MPC107 Revision 1.3 and 1.4: Comparison and Compatibility

This document describes electrical and functional differences between Rev 1.3 and Rev 1.4 of the MPC107 PCI Bridge/Memory Controller, which provides a bridge between the Peripheral Component Interconnect (PCI) bus and the MPC603e, MPC740, MPC750, MPC745, MPC755, MPC7400 and MPC7410 PowerPC™ host processors.

Figure 1. Rev 1.3 and Rev 1.4  $\overline{DBGn}$  Signal Timing

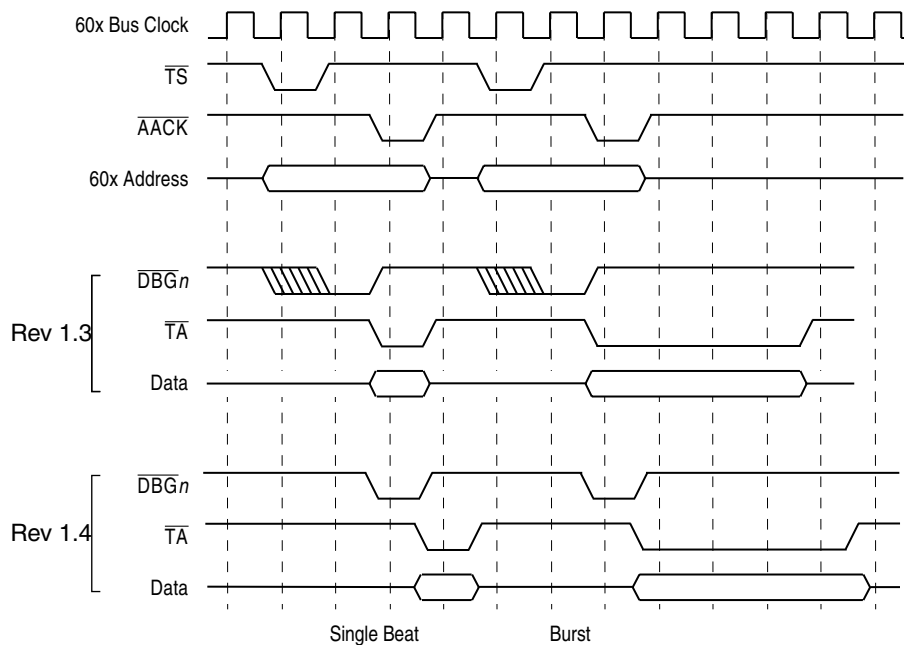
As described in Section 3.2, “MPC7450 Compatibility,” to guarantee that  $\overline{TA}$  is not asserted on or before  $\overline{AACK}$ , the timings for  $\overline{DBGn}$  and  $\overline{DBGLB}$  were changed in Rev 1.4 to fix the MPC7450-compatibility problem. Before Rev 1.4, the MPC107 may drive  $\overline{DBGn}$  (and  $\overline{DBGLB}$ ) as early as the cycle in which  $\overline{TS}$  is asserted. Figure 1 shows the signal timing for  $\overline{DBGn}$  and  $\overline{DBGLB}$  on Rev 1.3 and Rev 1.4 devices.

For Rev 1.4 of the MPC107,  $\overline{DBGn}$  is asserted coincident with  $\overline{AACK}$ . If a Rev 1.3 system design incorporates external logic that depends on the timing of  $\overline{DBGn}$  or  $\overline{DBGLB}$ , the external logic must be modified to accommodate the altered timing of Rev 1.4.
